March 15, 2023
Project No. 20-0591

**Re: Geotechnical Engineering Reports – Updated Site Plan
Queen Mountain Plat**
4175 Iron Gate Road
Bellingham, WA 98226
Parcel No. 380308336210

GeoTest previously submitted a geotechnical engineering report titled *Geotechnical Engineering Report: Queen Mountain Plat*, dated September 3, 2020, for the currently undeveloped, approximately 36-acre parcel located at 4175 Iron Gate Road in Bellingham, Washington. This report contains a geologically hazardous area assessment and geotechnical recommendations pertaining to the 107-lot subdivision planned for the above referenced parcel. Our recommendations included, but were not limited to, mitigating potentially geologically hazardous areas, site preparation and earthwork, foundation support, criteria, placement, and compaction of structural fill, and lateral earth pressures.

On February 23, 2023, Freeland and Associates provided GeoTest with an updated site plan, dated February 14, 2023, for the Queen Mountain Plat project. It is our understanding the City of Bellingham is requiring that current or future revisions to plat layout be included within Geological Reports. The new site plan details 11

SHEET: **P3.1**

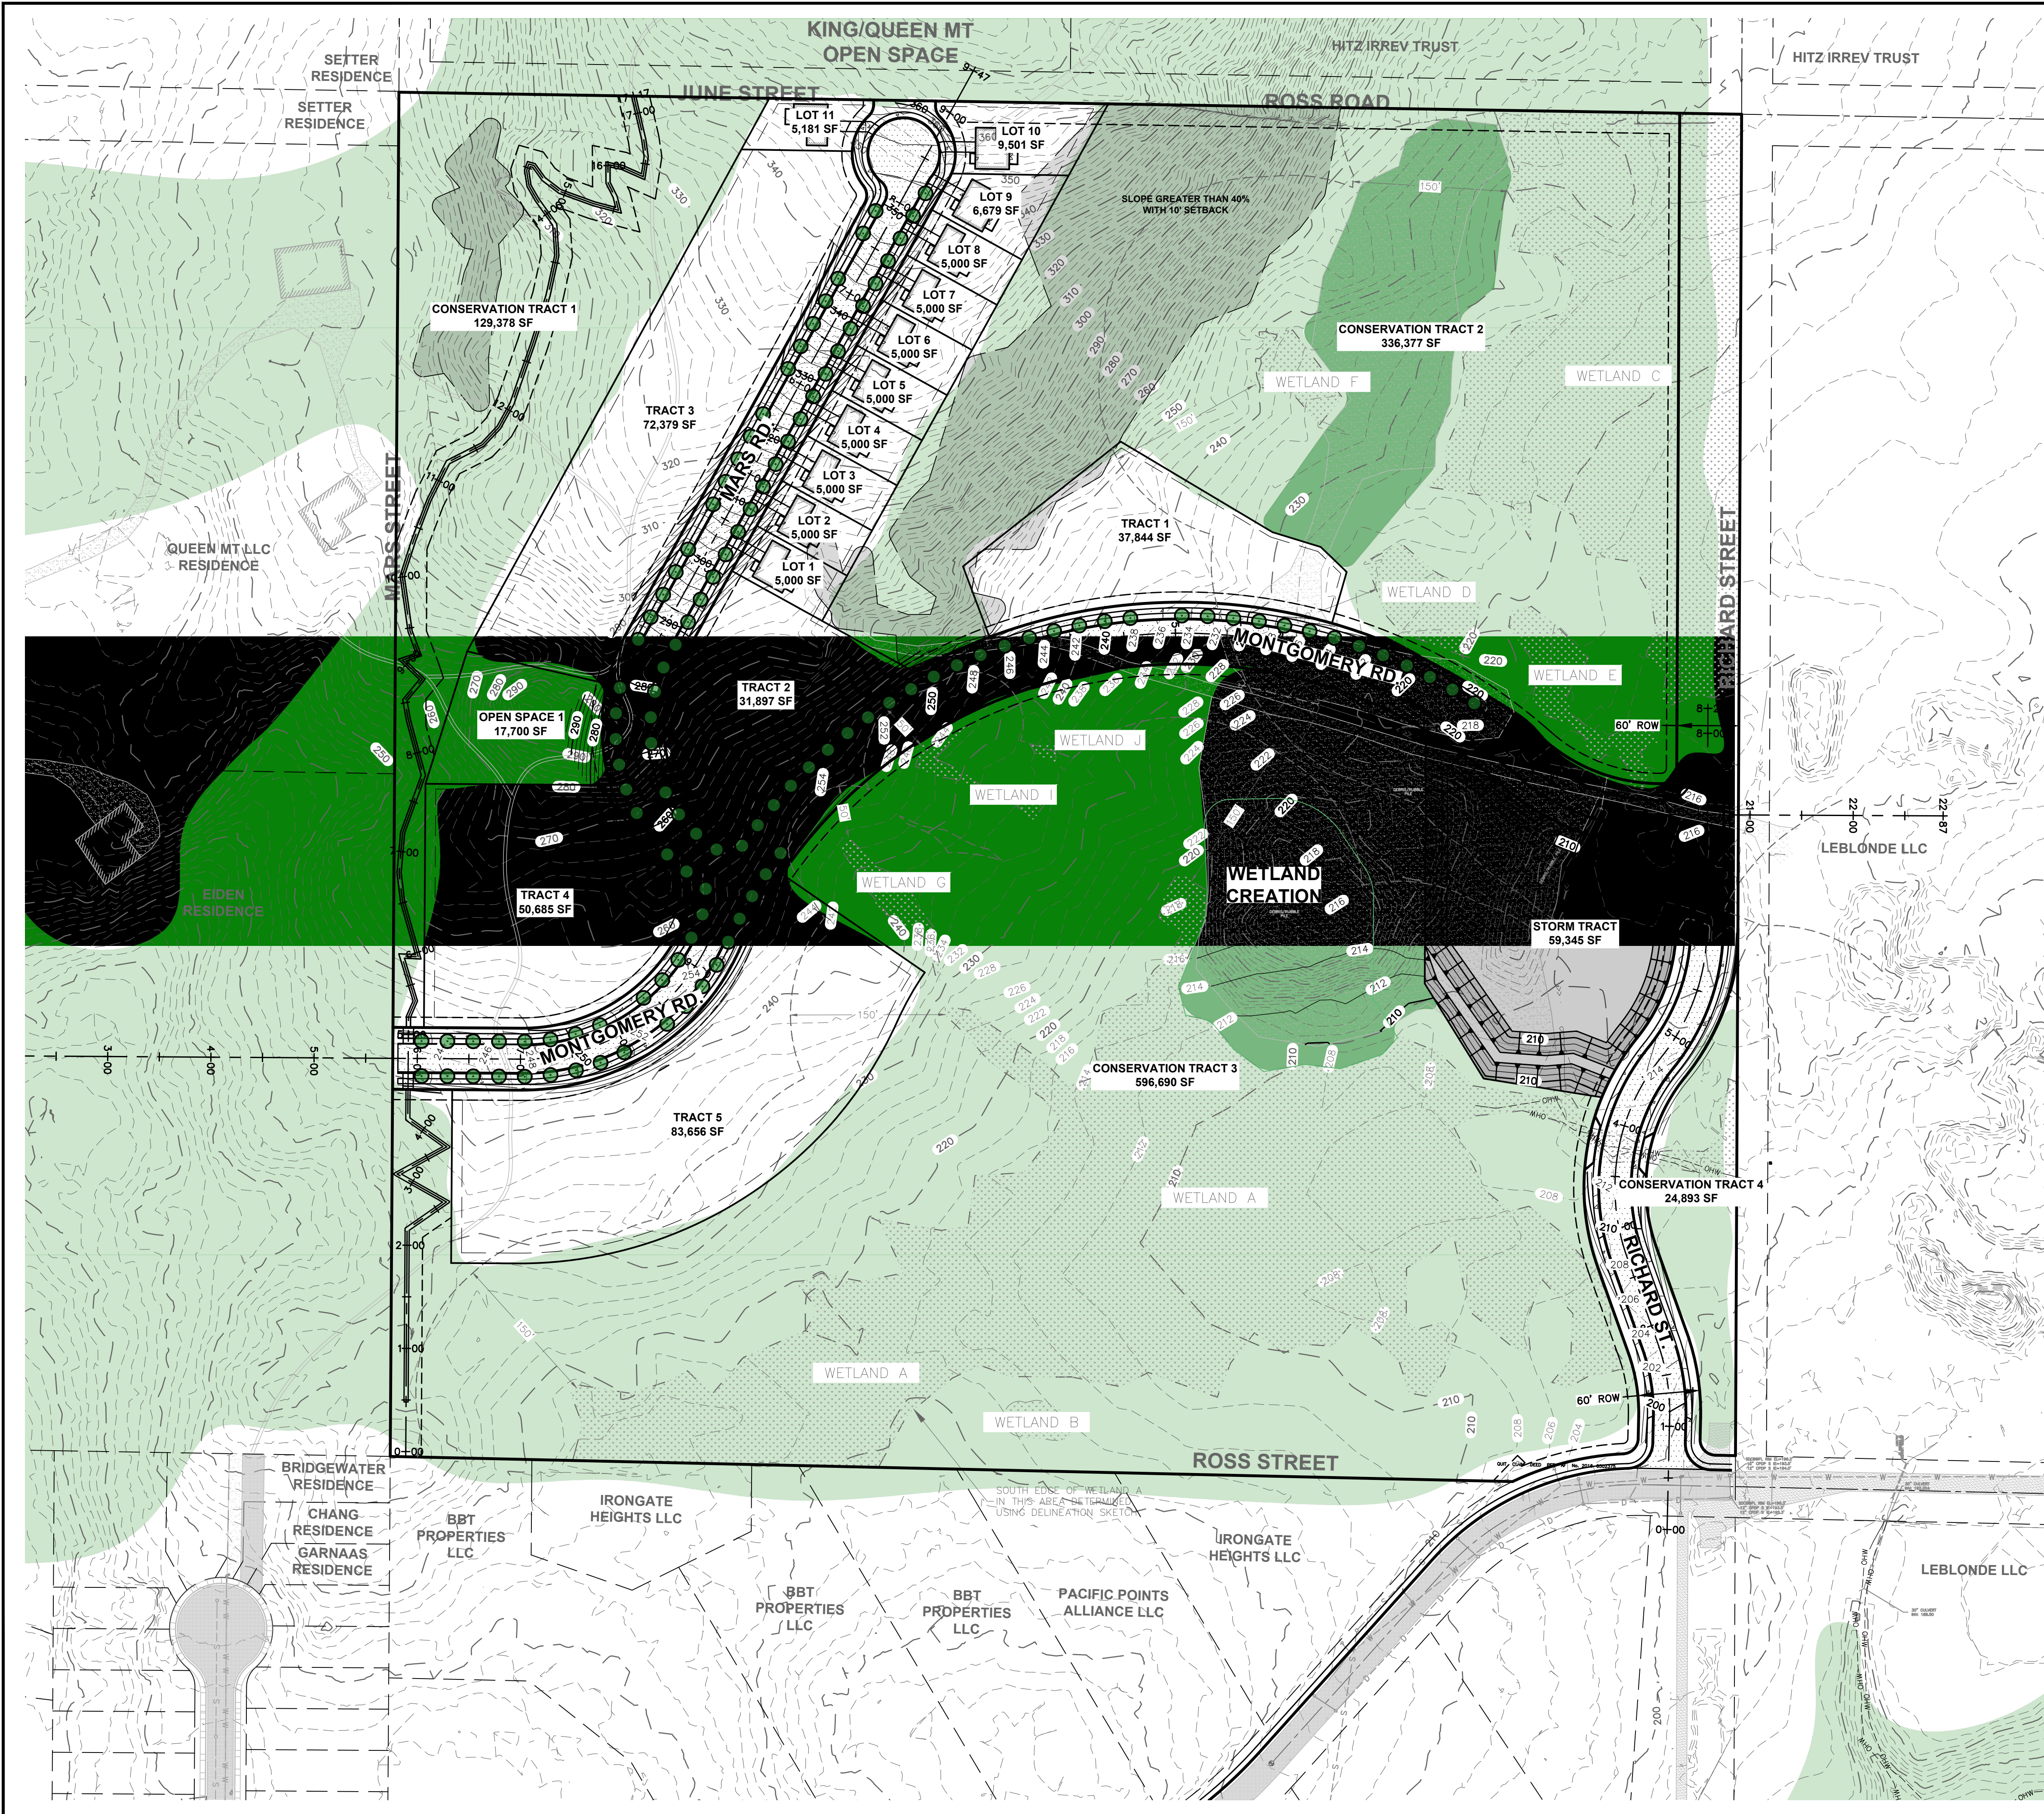
Based on our review of the updated site plan, the planned residential lots and tracts for future development are located in a similar location to the planned layouts depicted in previous site plans. Additionally, the new layout does not further encroach towards areas designated as potentially geologically hazardous areas. As such, the recommendations contained within our previously issued report and addendum letter are applicable to the updated site plan and should be incorporated into the project design and construction.

JOB #: 18271
DATE: 3-25-2022
SHEET: P3

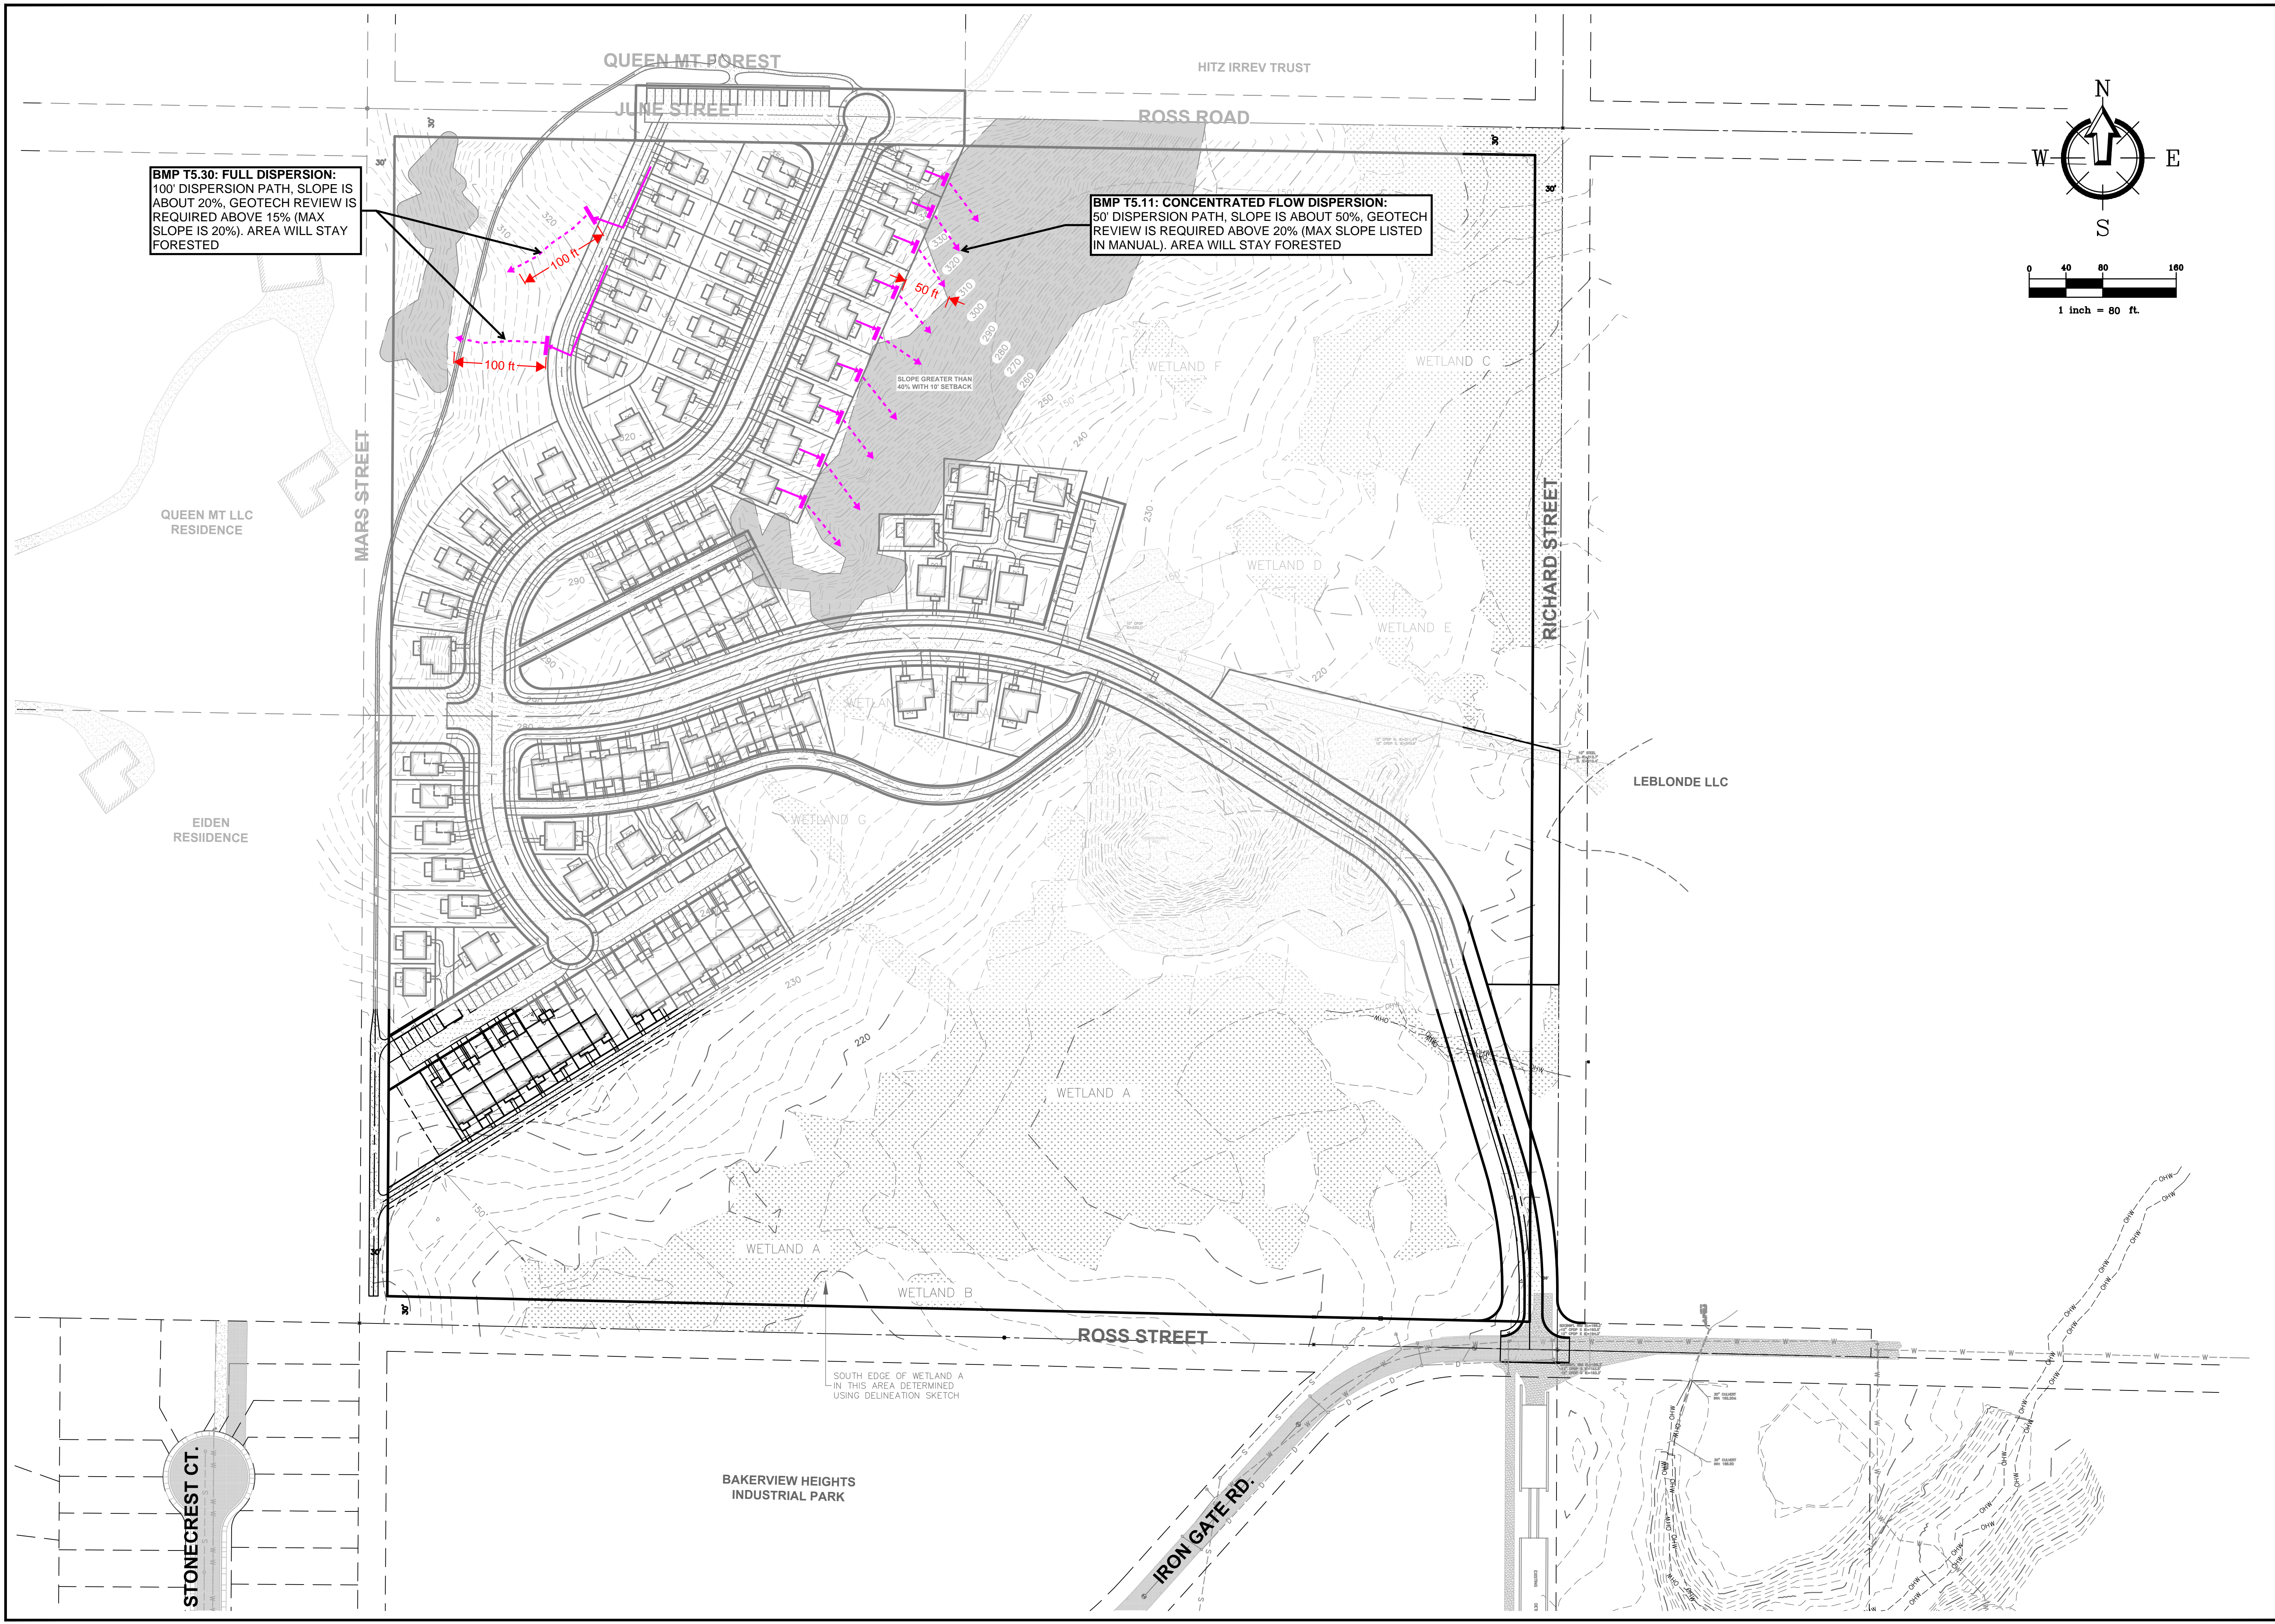
Herein we are requested by the team to provide review and commentary on the current plan for development as it relates to the dispersion of stormwater from residential housing above sloping terrain. GeoTest was provided with a preliminary site plan dated 3/25/2022 by Freeland and Associates (Freeland) for use in review. This document is attached at the end of this letter for reference. GeoTest and Freeland visited the proposed areas for stormwater management on March 31, 2022, to review existing conditions.

On review of the portion of the proposed plan for stormwater management that GeoTest is requested to review, we consider both locations to be suitable for the incorporation of dispersion BMPs as outlined above into the project plans. Both locations display shallow bedrock conditions with a mantle of low permeability glacial and recent soils that are completely forested in nature. We consider the proposed dispersion plan to present no changes to potential erosion or landslide concerns from what exists at present.

We recommend that in addition to maintaining the forested nature of the vegetated flow paths, that additional planting of native understory be considered by the design team where soil and slope conditions allow. The design engineer should follow prescribed setbacks and all design criteria as addressed in the SMMWW. GeoTest is available to provide final review of documents once they are generated by the design team, if requested.
